Felicia Miller - RE: Palmdale - Data Response 152 Inconsistencies

08-AFC-9

**PALMDALE HYBRID POWER PROJECT (08-AFC-09)
CEC STAFF SET 2 DATA REQUESTS 152 - 153**

Visual Resources
Attachment DR-153
Fogging Frequency Curve

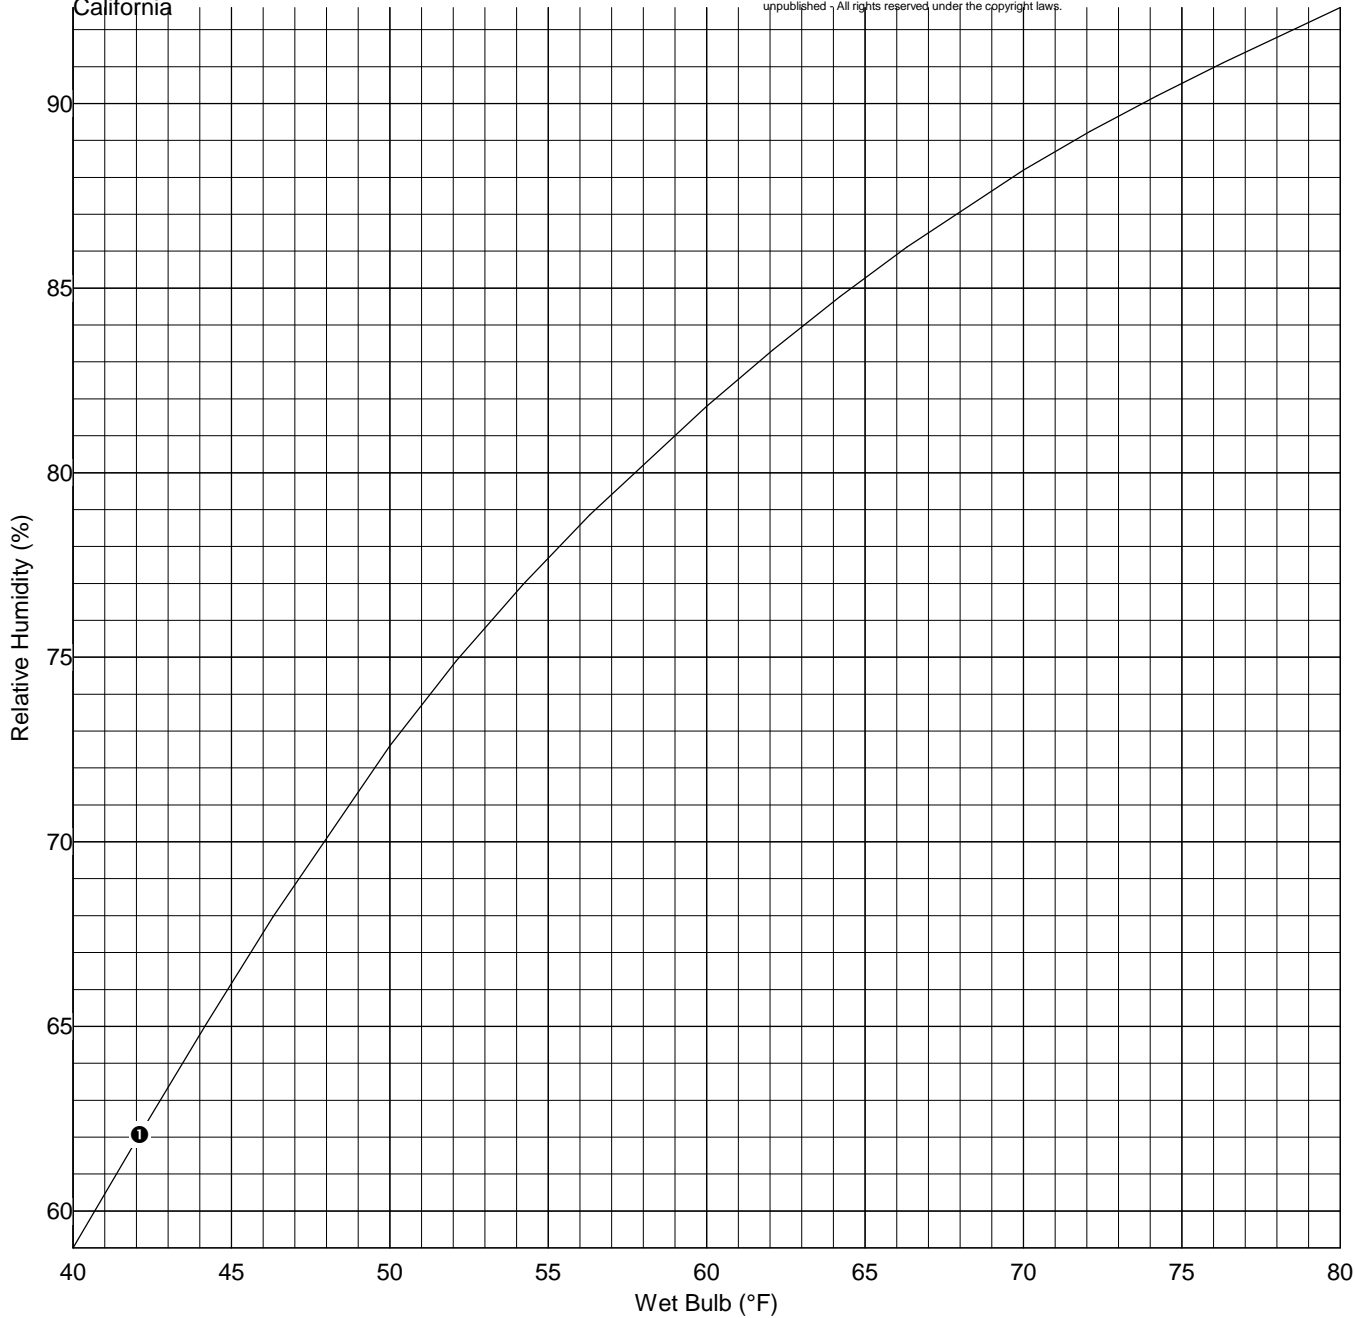
In addition, we are submitting the attached revised fogging curve that was recently provided from the cooling tower vendor. Please note the curve is virtually identical to the one previously submitted in our May 1, 2009 submittal. The only difference is that the fan motor horsepower has been reduced from 250 hp to 200 hp and the fan RPM was increased from 119 RPM to 146 RPM. Otherwise, all other design conditions remained the same.

The cooling tower design is based on an SPX/Marley F4910-5.3-10B cooling tower. A revised Fogging Frequency Curve is provided as Attachment DR-153 at the end of this section.
